LINCOLN COUNTY HEALTH DEPARTMENT
ENVIRONMENTAL HEALTH
AFFIDAVIT OF WASTEWATER TREATMENT AND DISPOSAL SYSTEM COMPLIANCE REVIEW FOR SYSTEM INSTALLED, REPAIRED OR REPLACED WITHOUT A VALID PERMIT

Address or Location: 111 Valley View Rd, Eureka, MT 59917-9398

TED ALLERS SITE MAP

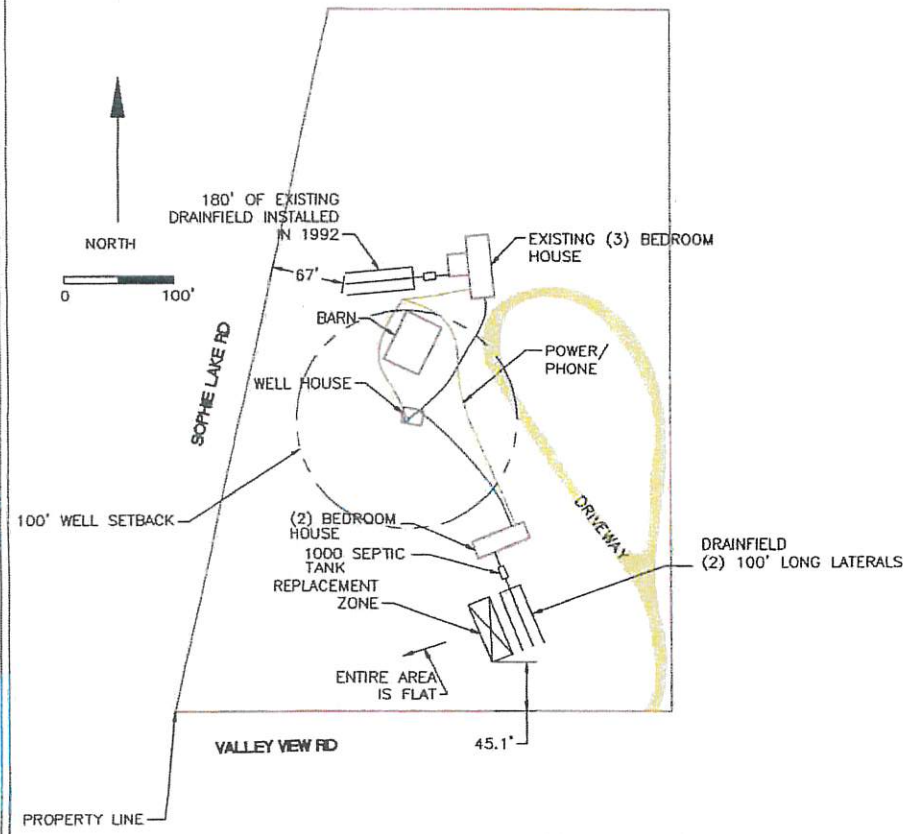
Comments: Gravity system using 1000 gallon tank and 2' wide trenches. Two laterals are each 100' long with chambers. Tank was pumped and filter cleaned 8/18/22 and reported to be in good condition. System is appropriately sized for wastewater flows of 300 gallons per day. Any future extension, repair, replacement or increase in wastewater flows must be reviewed and permitted by Lincoln County Health Department.

I, Kathi Hooper *, have reviewed the components of this system as listed above and found it to be in compliance with the requirements of A.R.M. Chapter 17.36 Subchapter 9, Circular DEQ-4 and Lincoln County Wastewater Treatment and Disposal Regulation.*
